Cabinet Member for Environmental Sustainability and Regeneration:

Date: 16th September 2015

Subject: Proposed RPC1 CPZ (Cottenham Park Road Area – Statutory Consultation)

Drawing No.Z78-212-02 Rev A (with amended proposals)

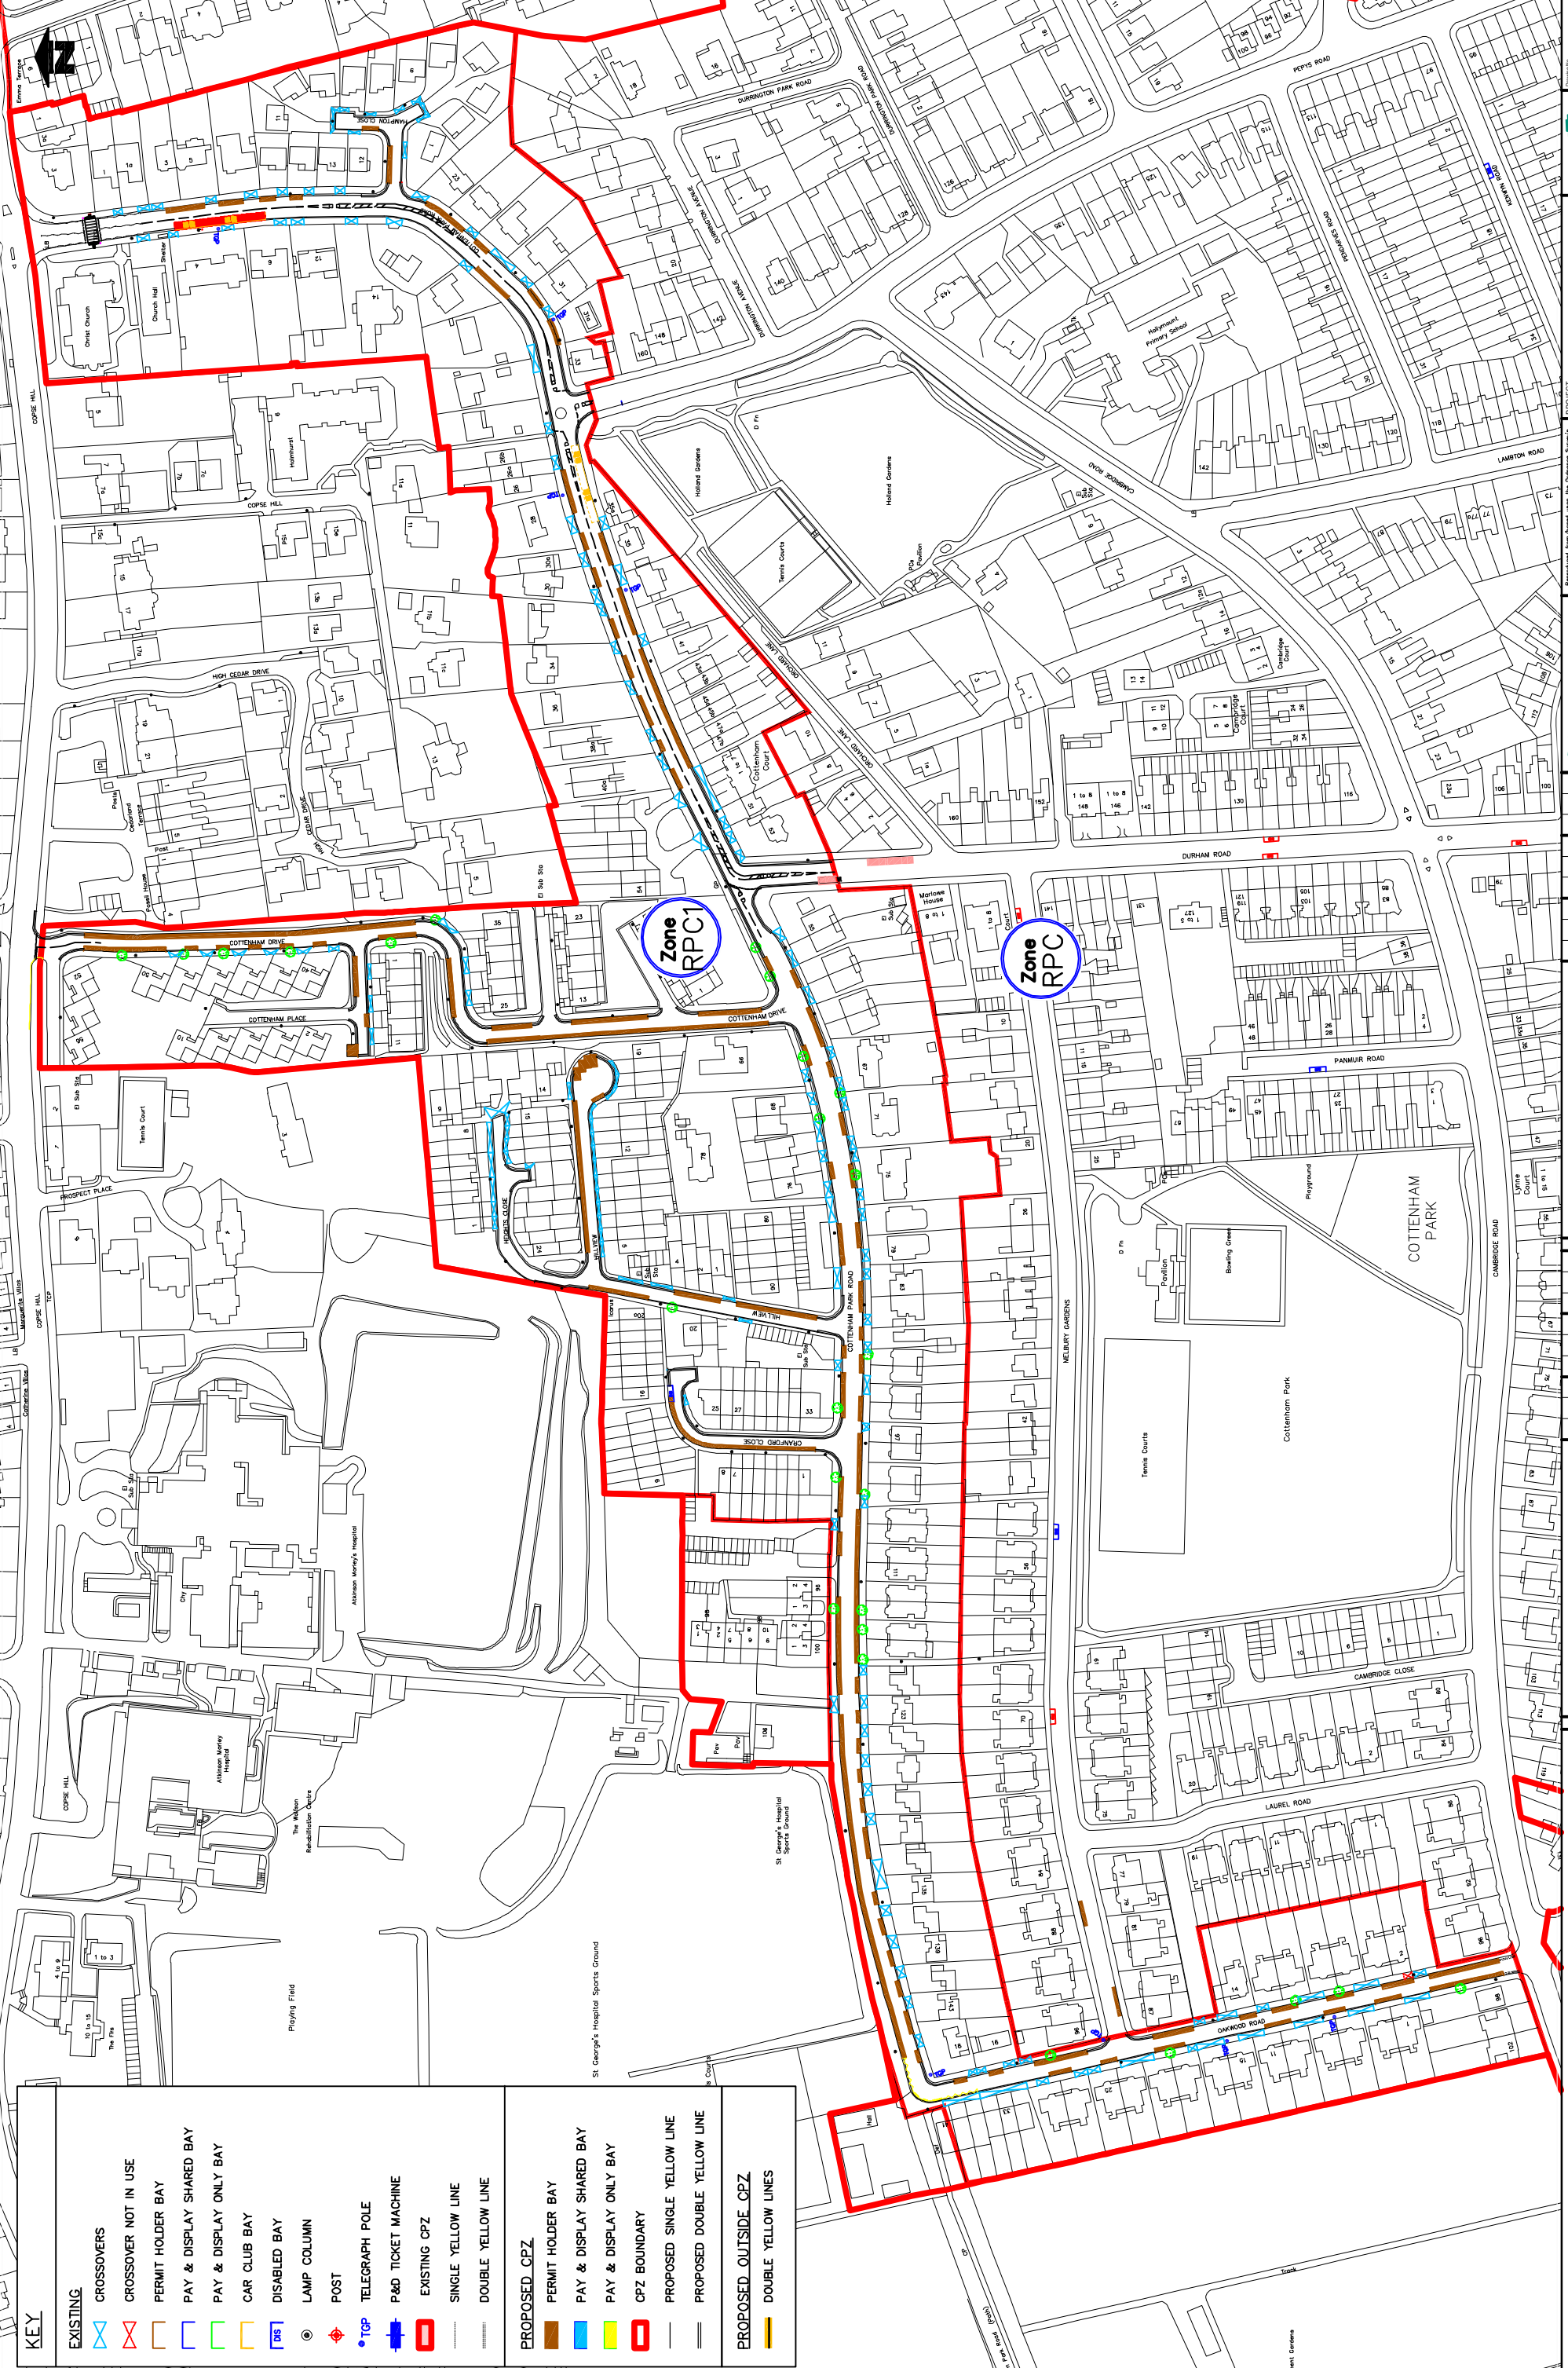
4.2 A concern was raised that the proposed scheme would have an adverse effect on many of the users of the Community Hall (Scout Hut), based at the corner of Cottenham Park Road and Oakwood Road in Raynes Park. To address this concern the proposed permit holder only parking bay opposite properties No.125 to 143 Cottenham Park Road will be amended to a shared use permit holder / pay and display parking bay to be utilised by visitors to the Community Hall and the St. George's Hospital Sports Ground.

4.3 Another concern was noted that a long standing problem with vehicles parking adjacent to the pedestrian refuge island between No.11 and 13 Cottenham Park Road resulted in a reduced carriageway width, insufficient for buses and larger vehicles to pass. To address this and assist with the expeditious and safe movement of vehicular and other traffic (including pedestrians) around the refuge

islands an amendment to the proposed scheme to introduce double yellow lines (waiting restrictions at any time) around the pedestrian islands in front of No.13 and No.23 Cottenham Park Road is recommended.

To address the views of the majority of the representations in each road who objected to the proposed parking controls in their road, it is recommended that Cottenham Drive, Cottenham Place, Cranford Close, Heights Close and Hillview are excluded from the proposed CPZ

4.1 In response to the feedback received from residents, the following amendments have been made to the original design. These are set out below and shown on Drawing No. Z78-212-02 Rev A in Appendix 2.
